**Errata to ASHRAE Pocket Guide for Air Conditioning, Heating, Ventilation, Refrigeration
(SI Edition)**

January 16, 2008

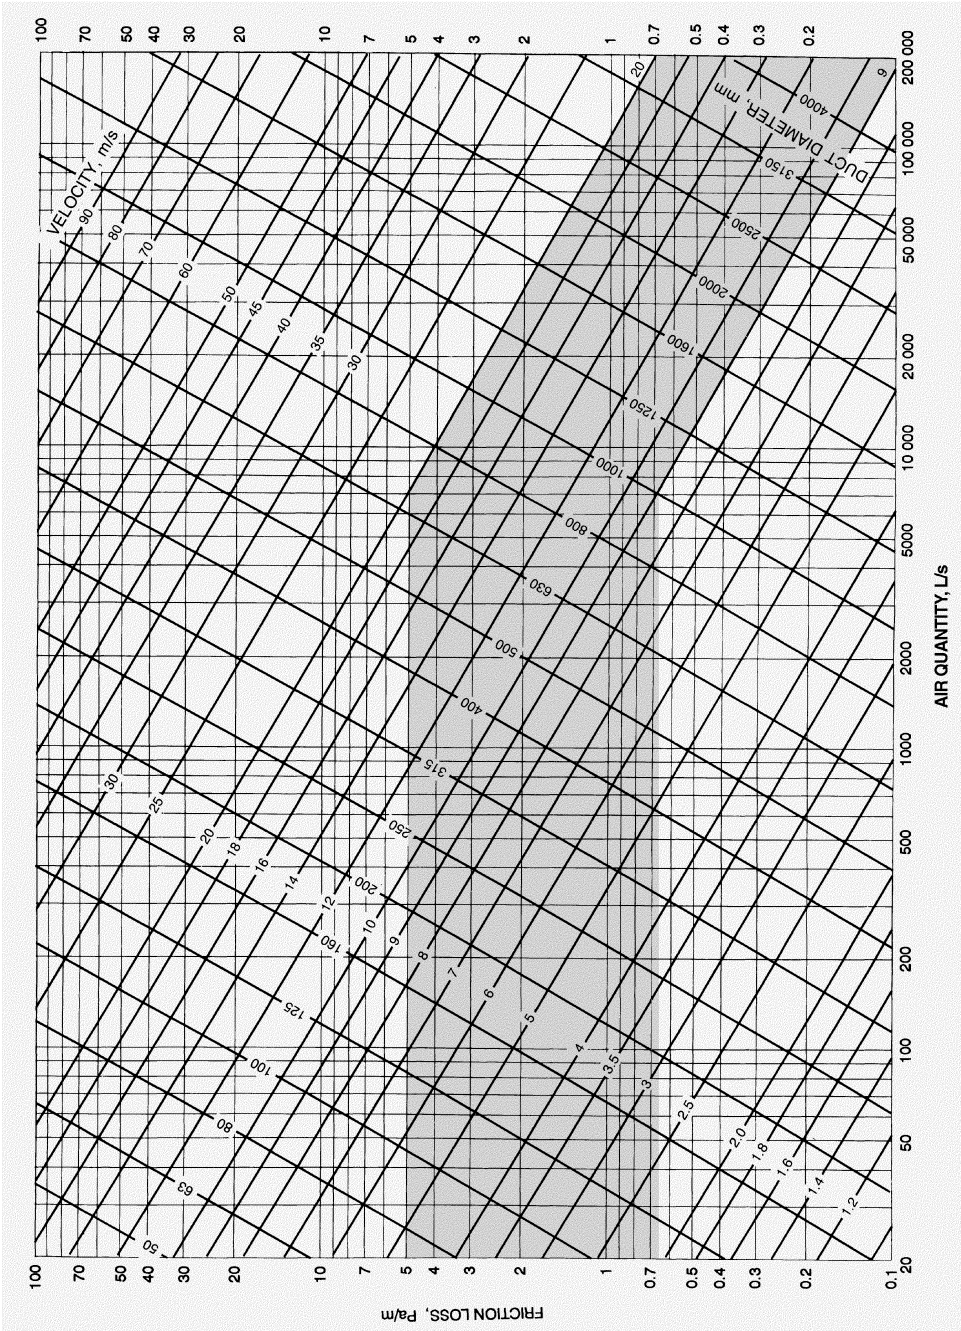
I-3 The graphs on these pages should be replaced with the single following graph, as data are missing for flow rates between 500 and 1000 L/s.
